Work Order ID 97432

Item ID: D407-667-205

Item Name: Crosstube Aft

DRAWING NO. D407-667-245	TITLE CROSSTUBE ASSY (407 HIGH AFT)	REV. F	DART AEROSPACE LTD ENGINEERING ORDER		D.E.O. NO. D407-667-245-F-1	SHEET NO. SHEET 1 OF 2	SCALE NTS
DRAWN <i>h</i>	CHECKED <i>q</i>	MFG. APPR. <i>e</i>	APPROVED <i>140</i>	DE APPR. <i>#</i>			
DATE 11.04.08	DATE 11.04.12	DATE 11.04.12	DATE 11.04.12	DATE 11.04.12

D407-667-245
ASSEMBLY DETAIL
(VIEW LOOKING FORWARD)

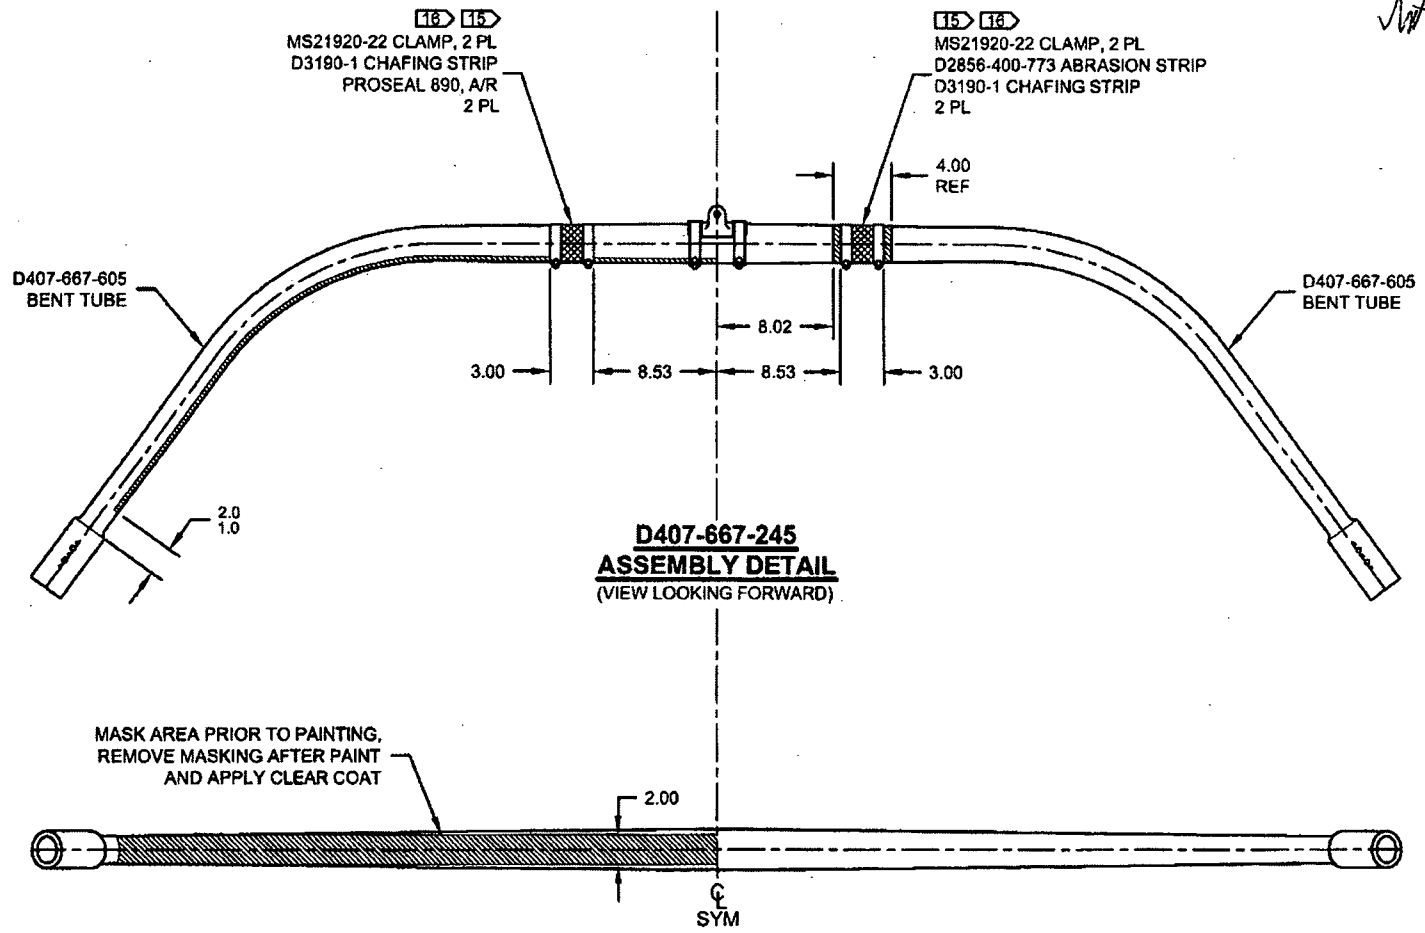
NOTES 2 AND 15, SHEET 1 ARE AMENDED AS FOLLOWS:

- 2) FINISH: CHEMICAL CONVERSION COAT PER DART QSI 005 4.1
PRIME INSIDE AND OUTSIDE PER DART QSI 005 4.2
MASK UNDERSIDE OF CROSSTUBE AS SHOWN (HATCHED AREA) AND
PAINT OUTSIDE PER DART QSI 005 4.2
REMOVE MASKING AND APPLY CLEAR COAT
- 15) APPLY A THIN COAT OF PROSEAL 890 ON INSIDE CONCAVE SURFACE OF D3190-1
CHAFING SHIELDS AND LET CURE PER MANUFACTURER'S INSTRUCTIONS. INSTALL
PROSEALED D3190-1 CHAFING SHIELDS ONTO CROSSTUBE BY APPLYING A THIN COAT
OF PROSEAL 890 ONTO CROSSTUBE. BE SURE TO ELIMINATE ANY AIR GAPS.

IS:

WAS:
